## Docket No. 272 - Development and Management Plan Inspection

## **Segment 3 Underground Line**

Date:	February 1, 2007		
Inspector:	Katie Bednaz		
пърсскот.			
I ocation:	Fact Dayon Substation to the Housatonic River Crossing

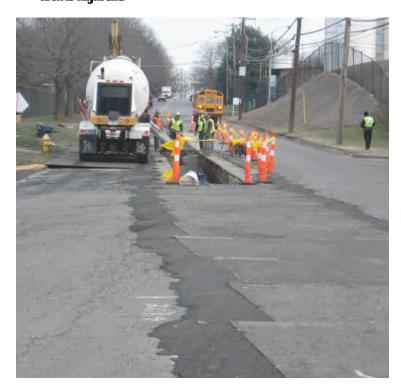
The uncontained concrete washout remains along the access road near station #1055. The concrete should be removed and properly disposed of.
